Amendment to the drawings:

REMARKS/ARGUMENTS

Applic. No.: 10/715,069
Amdt. Dated January 5, 2005
Reply to Office action of August 5, 2004

Fig. 2

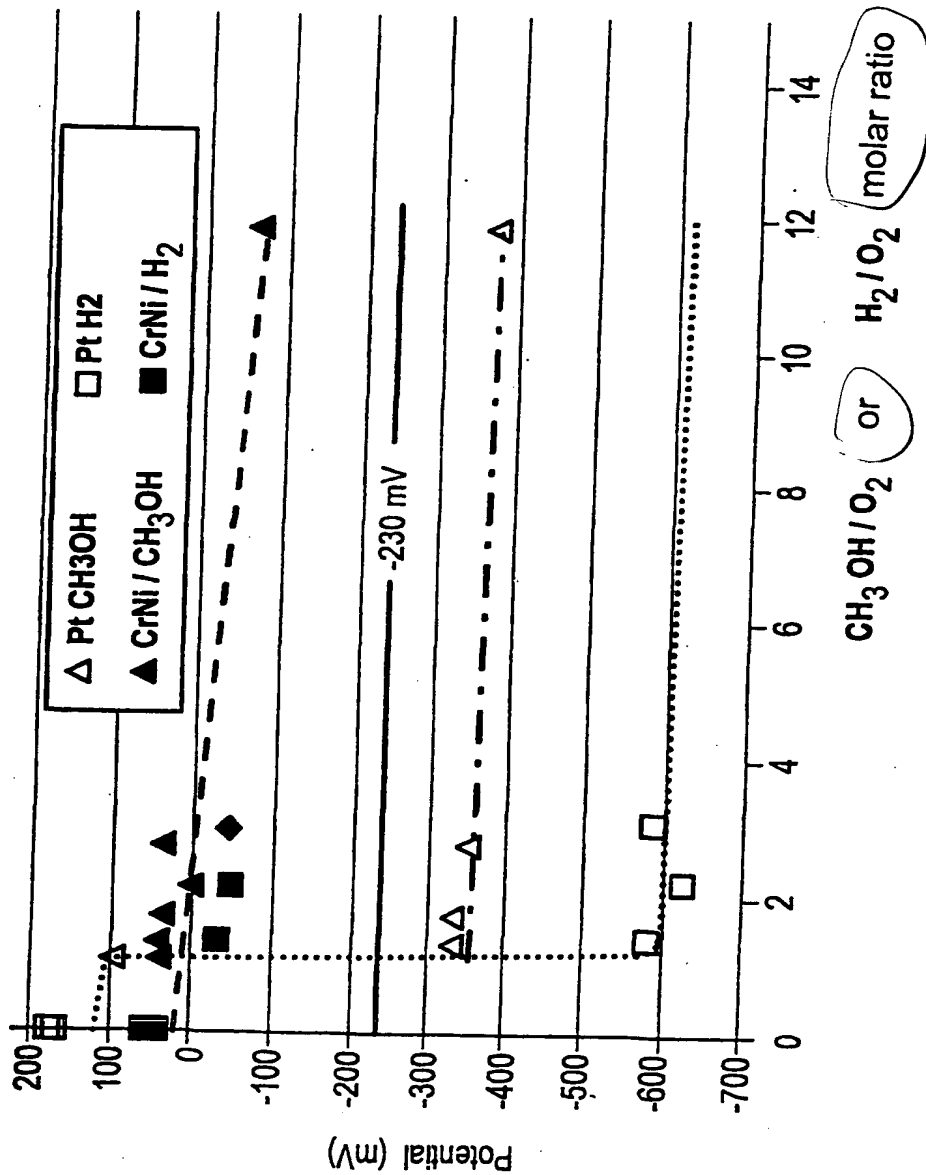
More specifically, the Examiner has stated that in Fig. 2 abscissa units are missing. Fig. 2 has been amended to clearly show the abscissa unit.

The attached sheet 2/2 of drawings includes changes to Fig. 2.
This sheet replaces the original sheet 2/2. In Fig. 2, the
abscissa has been clarified.
